Comments on #SDP-26-0004 - Planning & Zoning: Site Development Plan

Application Number: #SDP-26-0004
Application Type: Site Development Plan
Date: July 29, 2026
Address: 705 S MAIN ST, ROLESVILLE, NC 27571
Parcel: 1758574058

SITE DEVELOPMENT PLAN - SDP 26-__

REQUIRED VEGETATION PLAN
WALLBROOK SHOPPES (LOT 5C)

C0.1

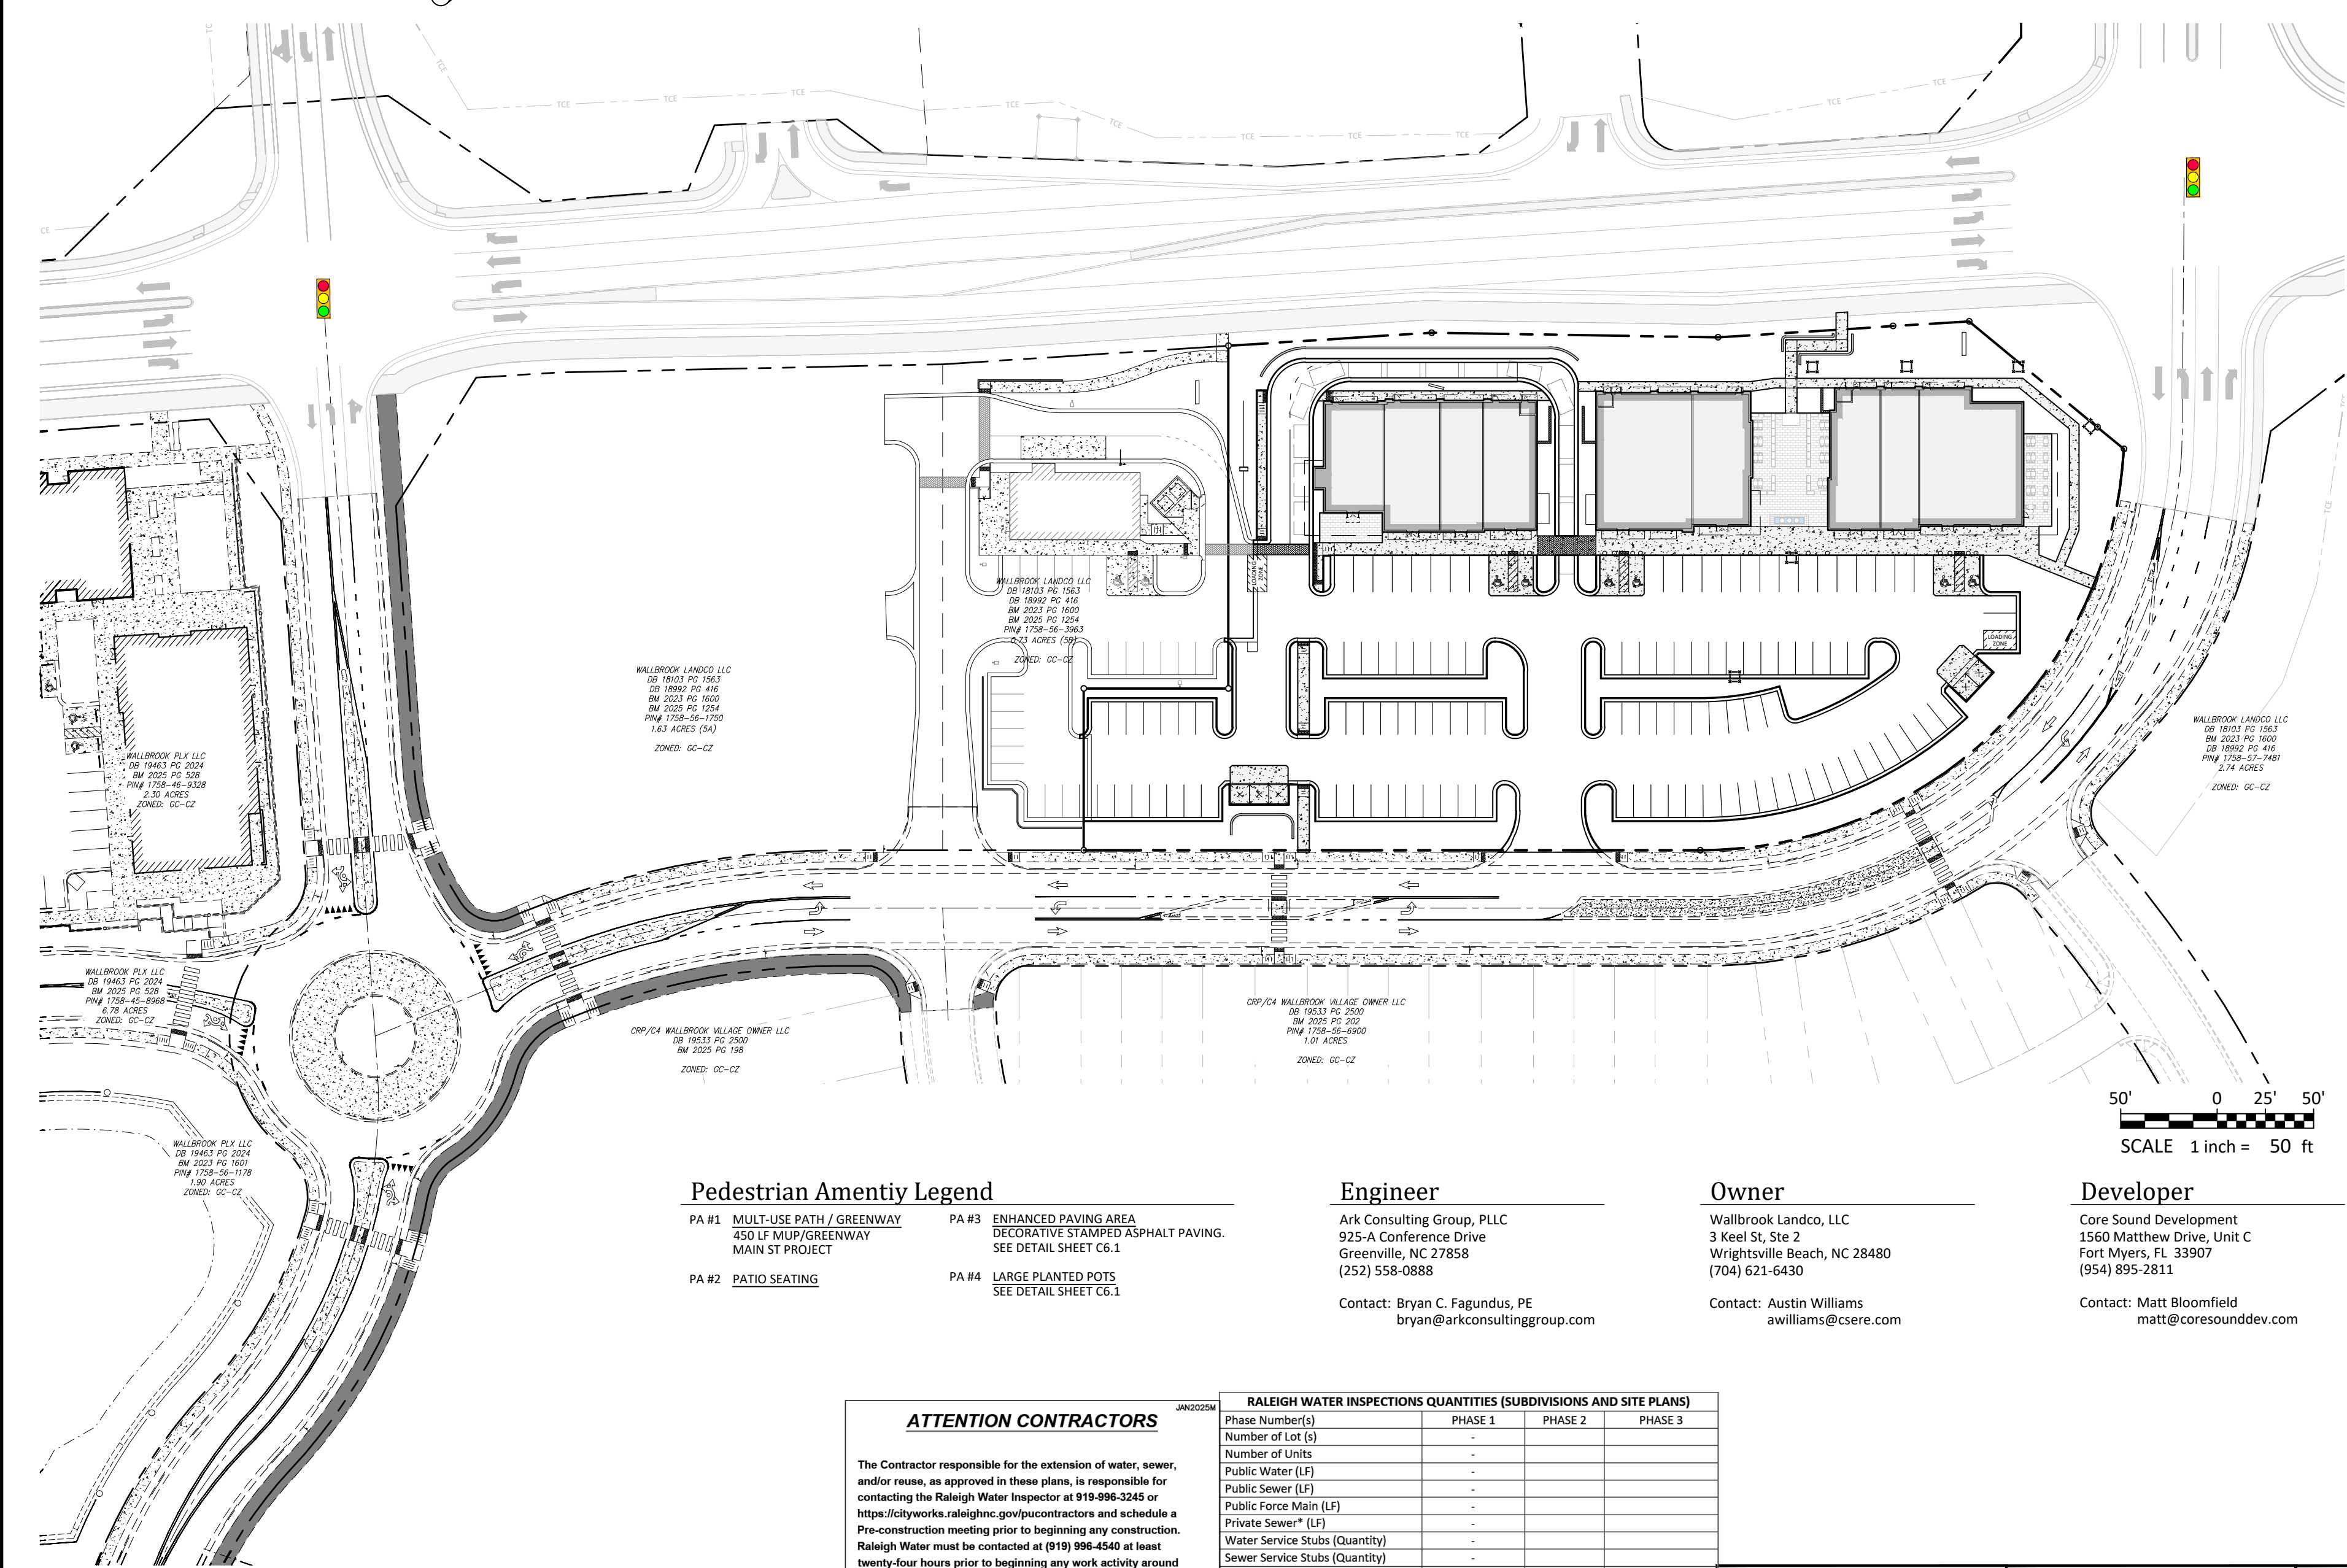
add "0004" here and then on all sheets in common place.

Repeat - add address for LOT 5C which per IMAPS is 705 S Main.

can more specificity be added than "non-residential" - Retail sales and Service, office, Eating establishments should cover all possibles based on precedent...

1 Michael Elabarger
add "0004" here and then on all sheets in common place.

2 Michael Elabarger
Repeat - add address for LOT 5C which per IMAPS is 705 S Main.

3 Michael Elabarger
can more specificity be added than "non-residential" - Retail sales and Service, office, Eating establishments should cover all possibles based on precedent...

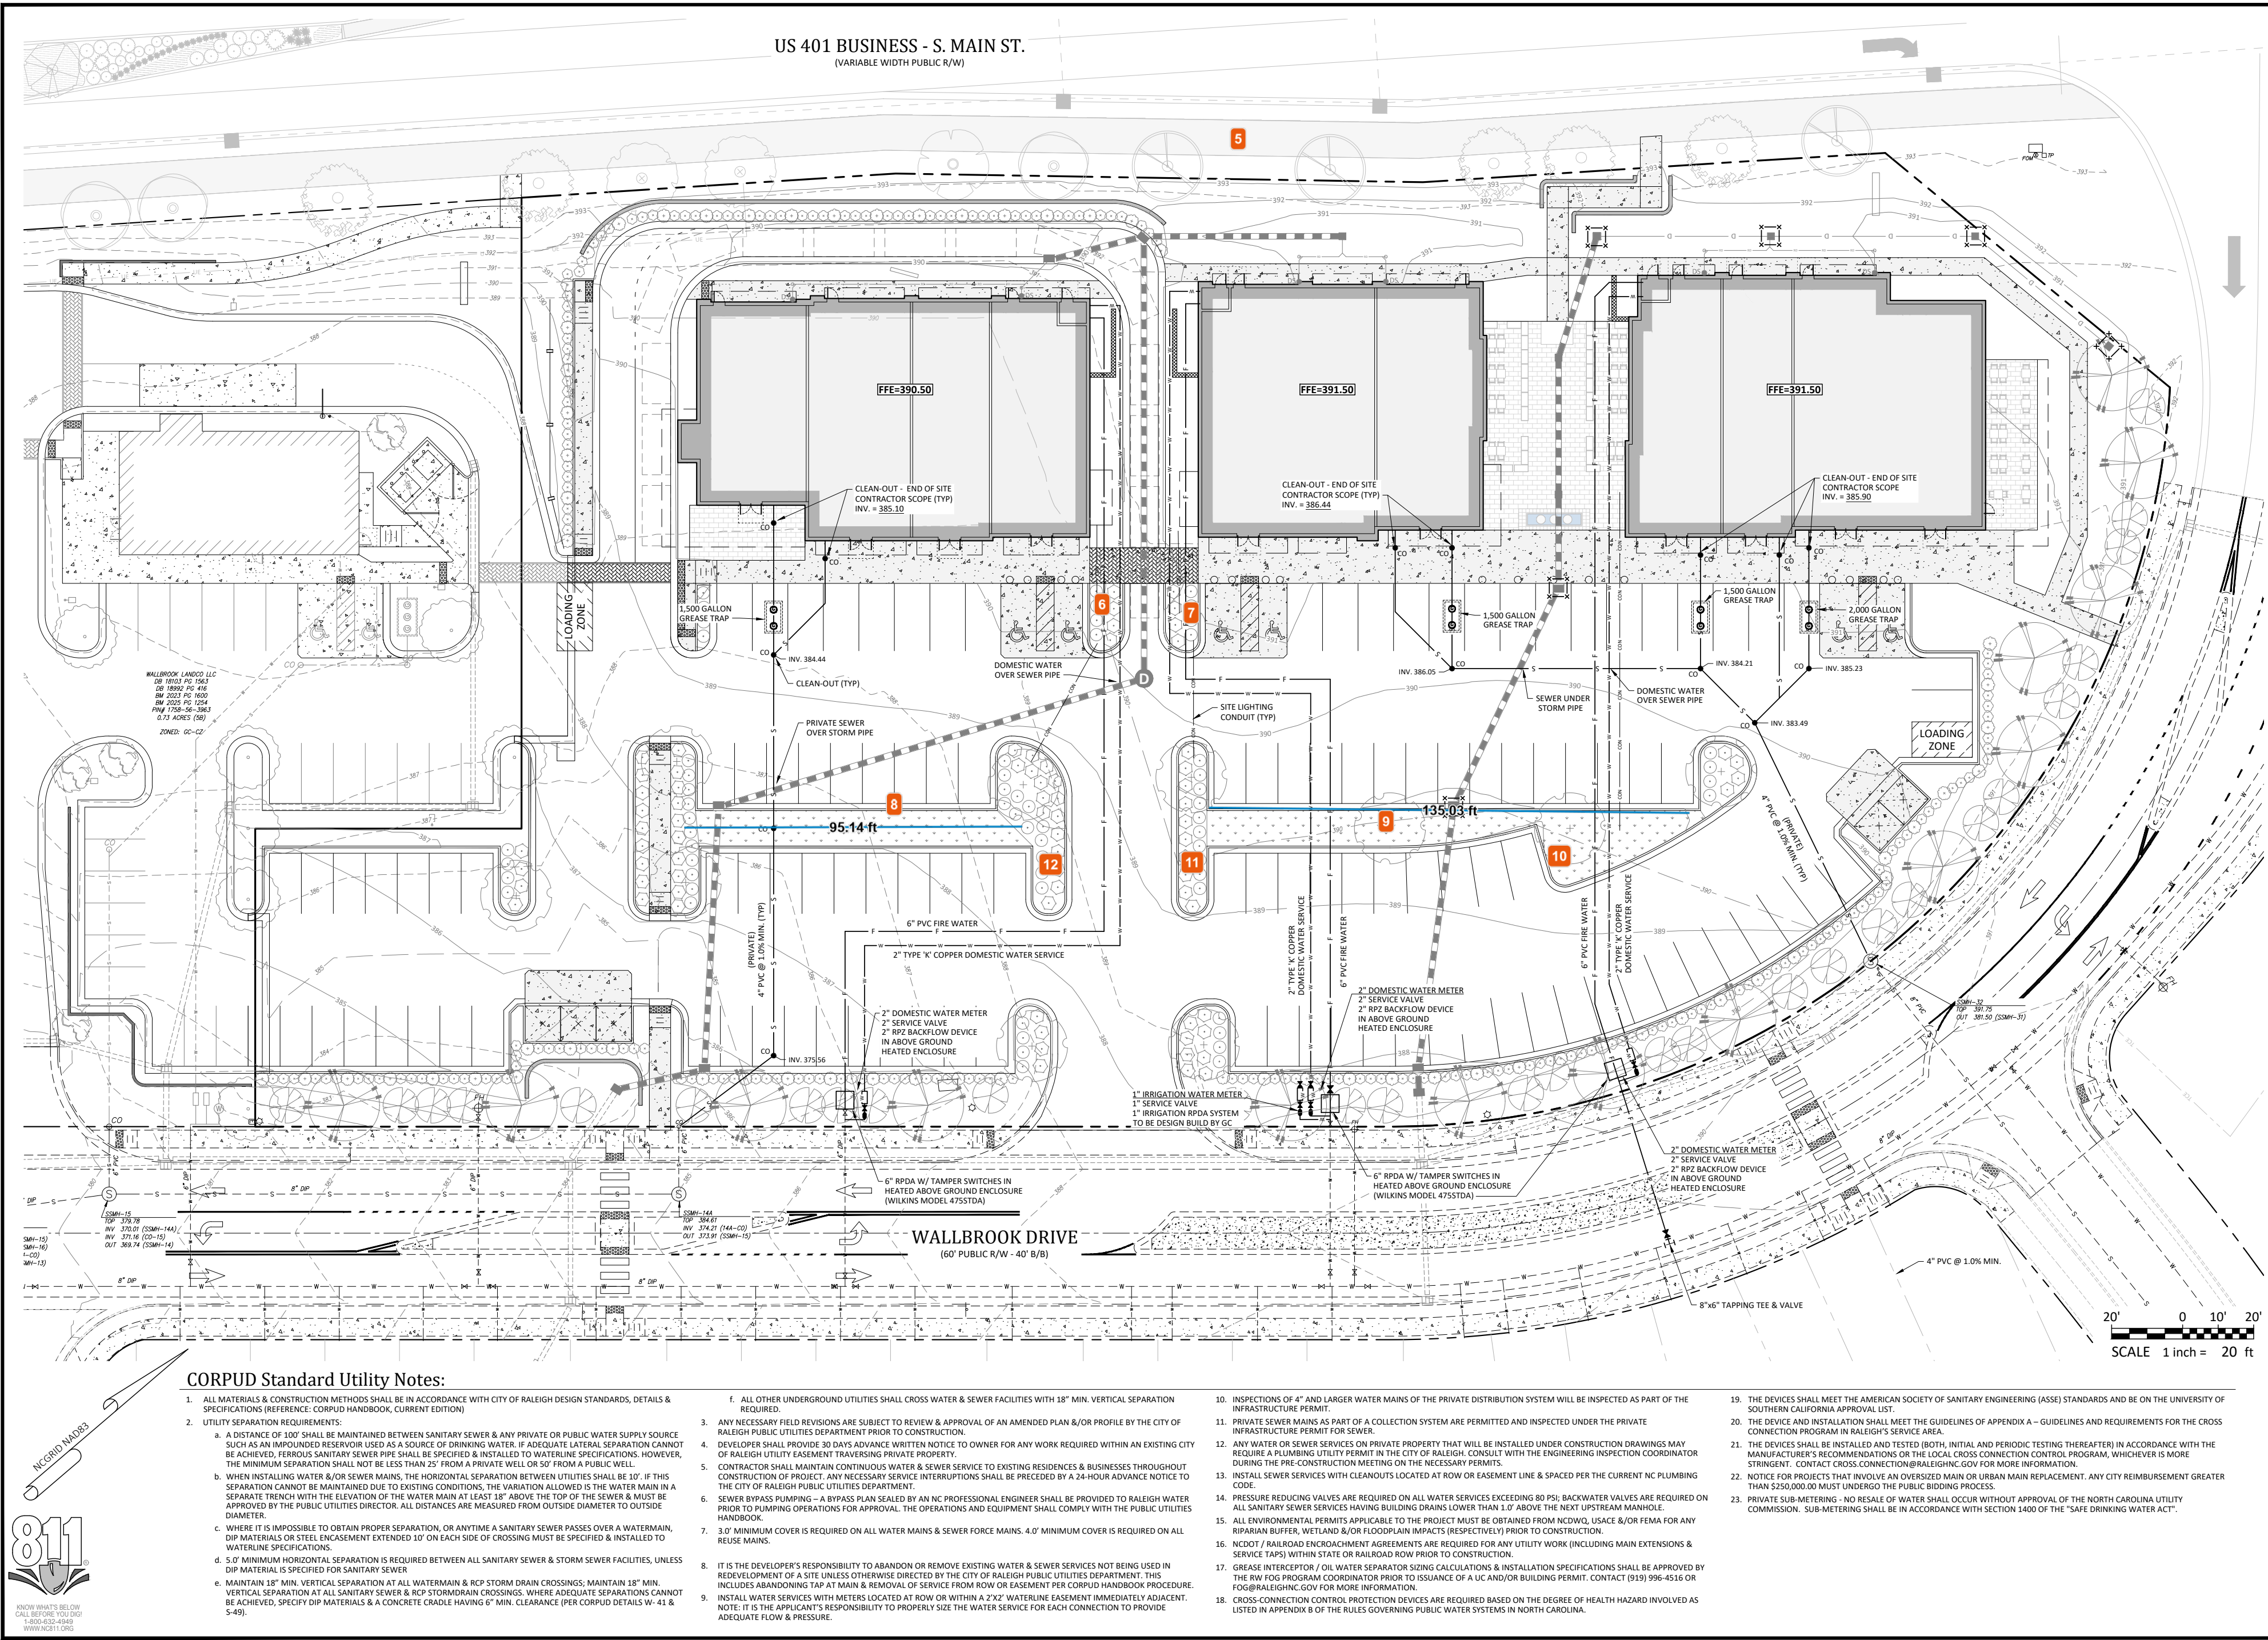
- ** Per the plan review comments on May 7th, this new plan was supposed to contain the following updates:
** Reviewed site plan. I contacted Lee Christman with Ark Consulting and he is going to provide some additional information prior to issuing comments:
1. Fire truck turning diagram in front of 701 S Main St
 2. FDC locations for buildings with sprinkler systems...
